SUBJECT: **ADDENDUM #6 TO THE BIDDING DOCUMENTS FOR:
NORTH & SOUTH HIGH SCHOOL BID GROUP #6 Phase B**
MASTER FACILITY PLAN IMPLEMENTATION
COMMUNITY HIGH SCHOOL DISTRICT 99

Project Name: District 99 MFP Implementation DG North High School
Project Number: 5274-43
Date: September 30, 2019

Bid Question/Answer Log No. 1

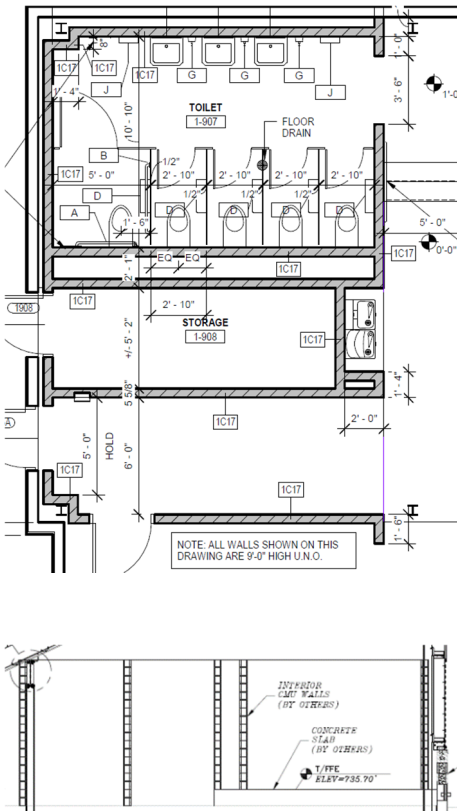
51. In our take-off, we have all interior CMU partitions 9' high per the original plans (see the first detail below).

Now per the addendum 3 plan pages the interior CMU partitions are 12' and 10'8" high. See the second detail below.

The last detail below says "9' high CMU wall", but actually the wall is 12' high if we count the CMU courses.

What height CMU partitions you want us to include in our scope? Please advise ASAP.

CMU partitions are 9'-0" high. I am not sure what drawing the second clip is from.

C2.02

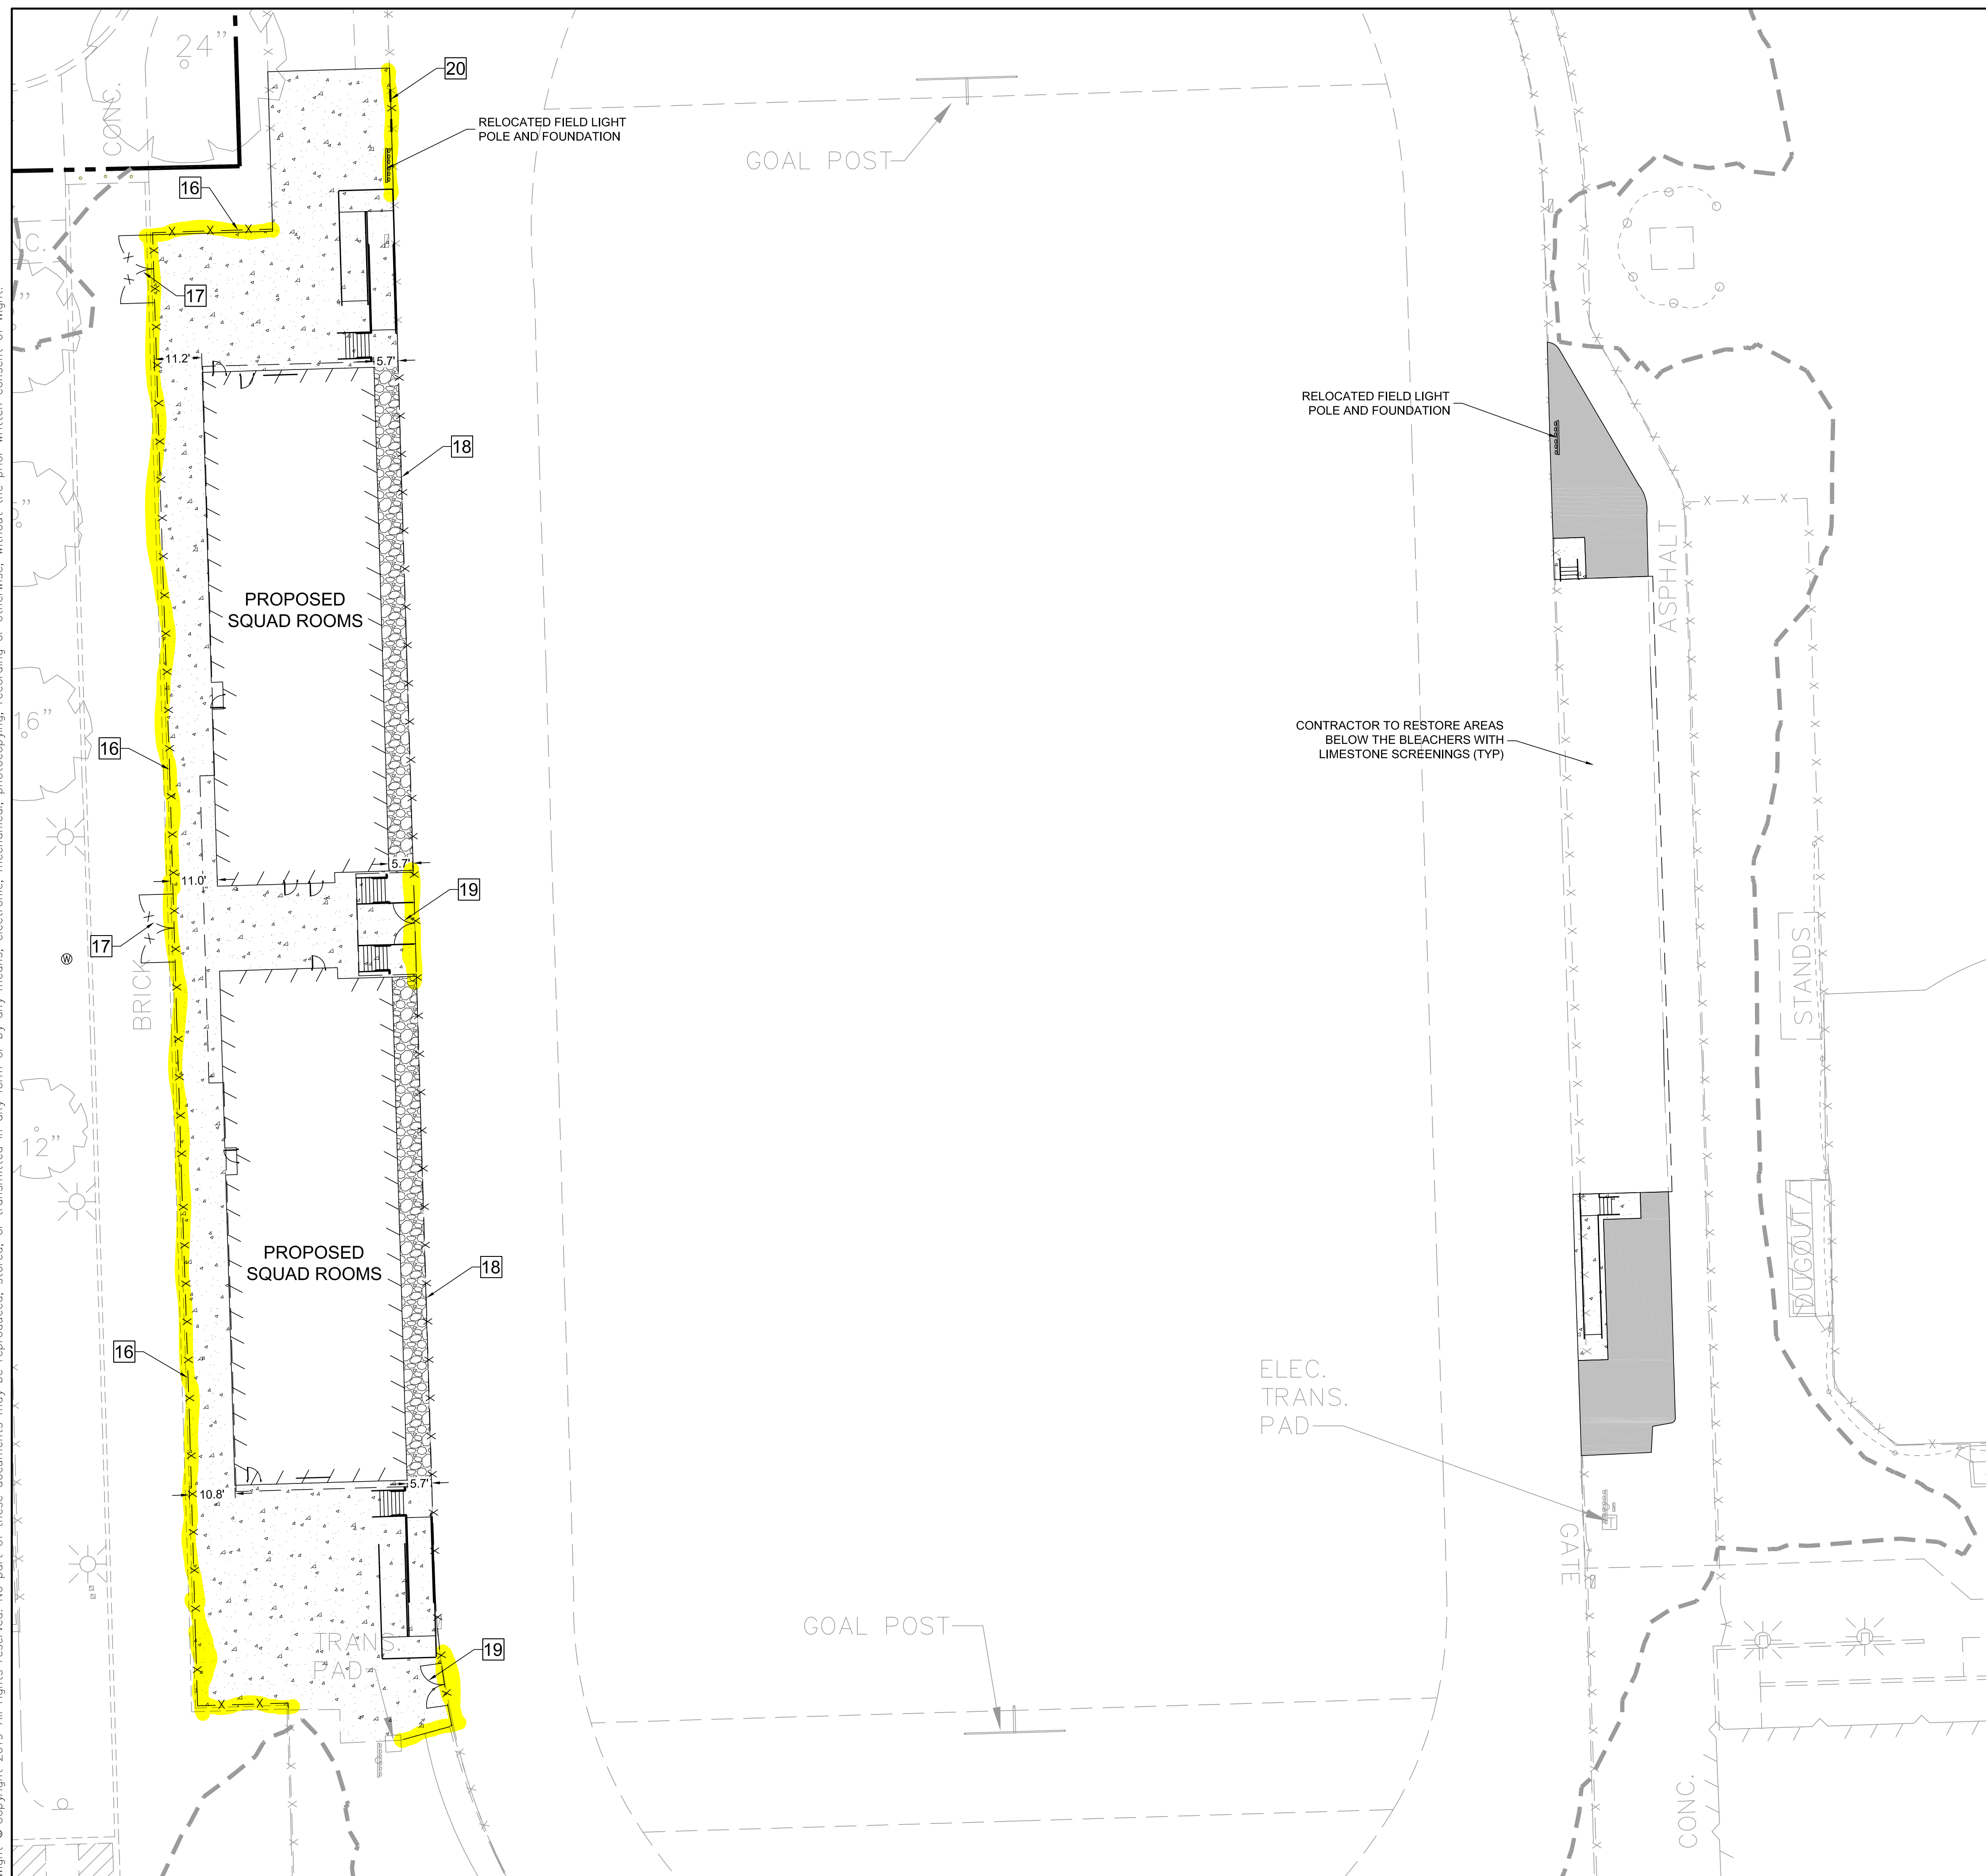
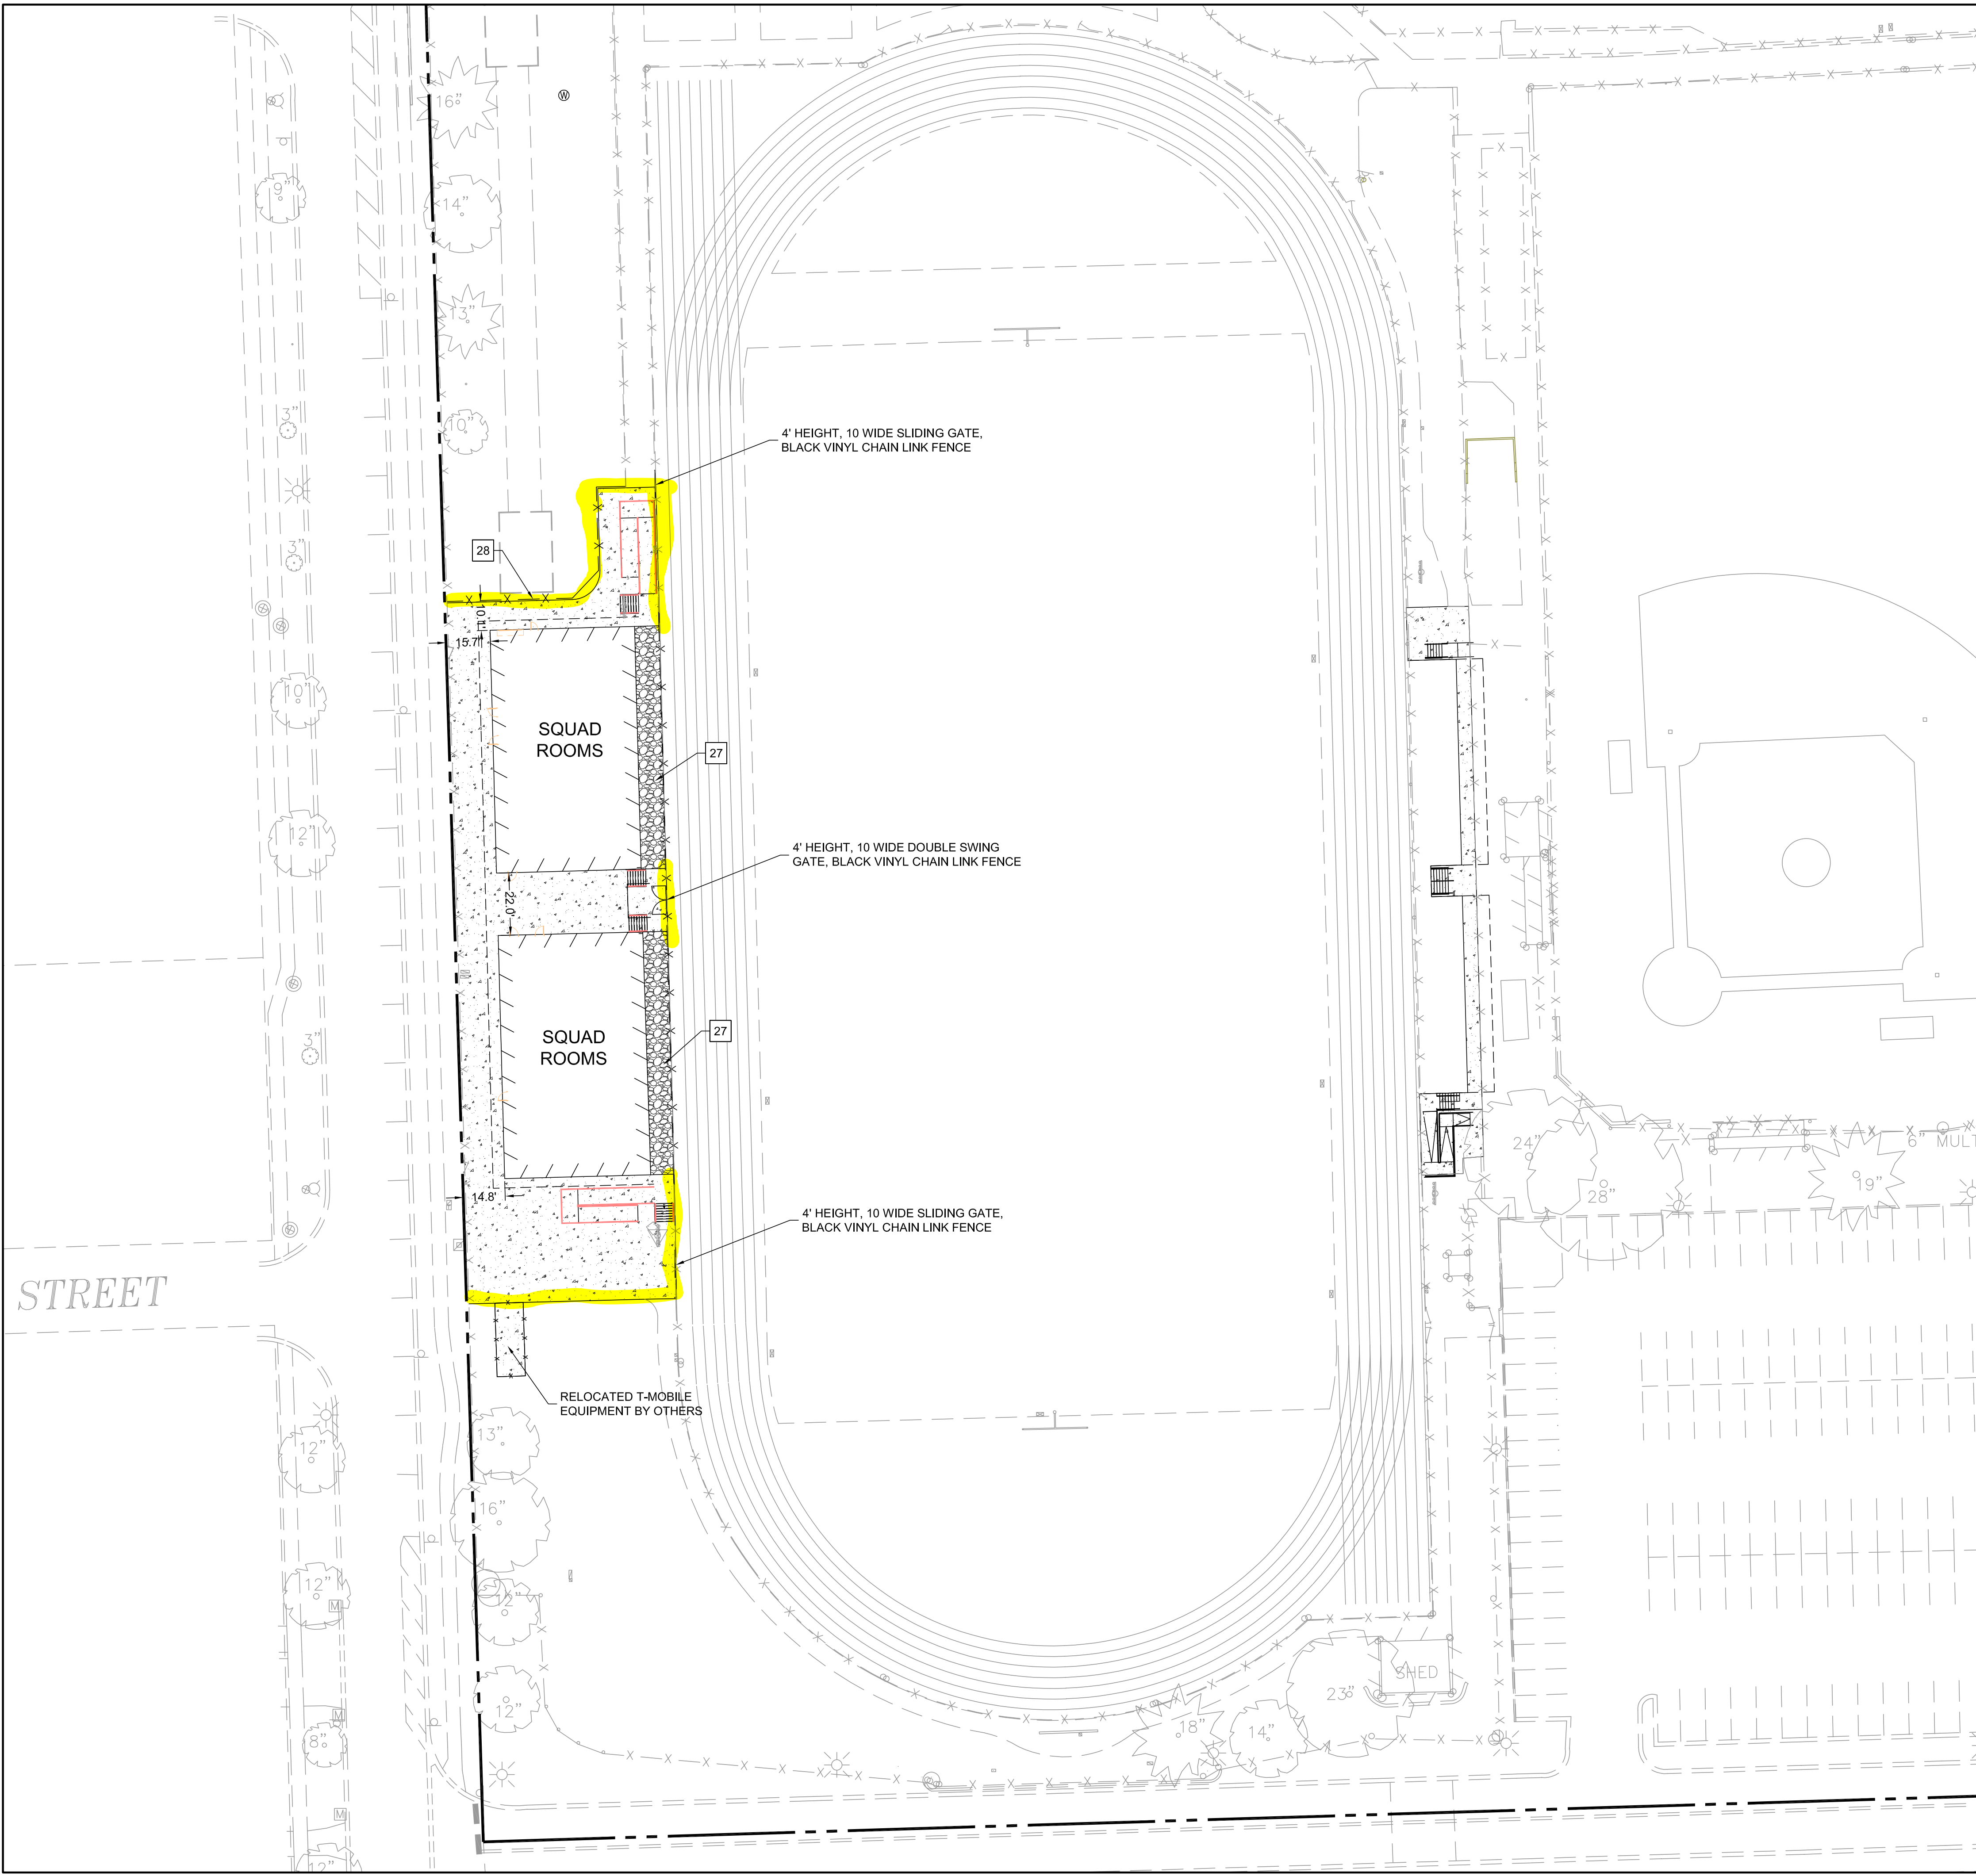
11.	(NORTH & SOUTH) On drawing C2.02 key notes 16 and 17 calls for a decorative metal fence. There is no mention in the general trades bid package to include this fencing.		Yes this fencing needs to be included in the bid package.	NAS 9-10-19

12.	(NORTH & SOUTH) Key note 17 calls for a 10' wide decorative metal double swing gate however when scaling the gate opening I'm coming up with a 16' opening. Please clarify.	9-9-19	Follow key note on both projects. Double swing gates identified in key Note #17 at North High shall be 10 feet wide.	DS 9-20-19

13.	(NORTH & SOUTH) Please confirm key note 18,19 and 20 as highlighted confirms the limits of the 4' tall fence per the attached drawing is part of the general trades bid package.	9-9-19	The 4' black coated vinyl Fence directly in front of the bleacher system at both north and south is by the Bleacher Contractor and is part of their scope of work. Everything else you have highlighted is to be included in the bid package.	NAS 9-10-19
